# Access Compliance Report

## Public Rights-of-Way

Intersection ID: 28119	Main Street: OLYMPIC CLUB DR	Cross Street: THREE LAKES DR	Location: SW
ADA ID: 419252CCC4EC	Ramp Type: PerpDiag	Initial Pass/Fail: Fail	Overall Compliance: No
Severity Score: 25			
Codes/Mitigation Info/Possible Solution		Field Measurements/Component Compliance

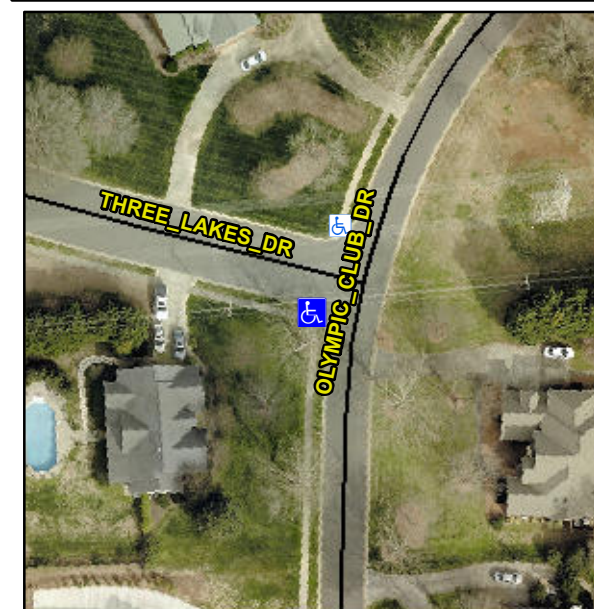
**Not Found, R304.2.2**

Compliance	Description	Data	Compliance	Description	Data
N/A	Ramp Length (in)	101.5	No	Ramp Slope (%)	12.9
Yes	Ramp Width (in)	53.0	Yes	Ramp XSlope (%)	0.1
N/A	Flare Type LT	N/A	N/A	Flare Type RT	N/A
N/A	Flare Slope LT (%)	N/A	N/A	Flare Slope RT (%)	N/A
N/A	Flare Traversable LT?	N/A	N/A	Flare Traversable RT?	N/A
N/A	Landing Length (in)	N/A	N/A	DWS Provided?	N/A
N/A	Landing Width (in)	N/A	N/A	DWS Contrast?	N/A
N/A	Landing Slope (%)	N/A	N/A	DWS Length (in)	N/A
N/A	Landing X Slope (%)	N/A	N/A	DWS Full Width?	N/A
N/A	Landing Curb? (Y/N)	N/A	N/A	DWS Offset (in)	N/A
N/A	Shared Landing?	N/A			
N/A	Gutter Ponding?	N/A	N/A	Gutter Slope (%)	N/A
N/A	Gutter Lip Ht (in)	N/A	N/A	Gutter X Slope (%)	N/A
N/A	Painted X Walk1?	No	N/A	Painted X Walk2?	No
	X Walk 1 Direction	To SE		X Walk 2 Direction	To NW
N/A	X Walk 1 Width (in)	N/A	N/A	X Walk 2 Width (in)	N/A
	X Walk 1 Slope (%)	1.3		X Walk 2 Slope (%)	4.2
	X Walk 1 X Slope (%)	3.2		X Walk 2 X Slope (%)	0.2

**Remove & Replace Curb Ramp With Two New Directional Ramps or Equivalent.**
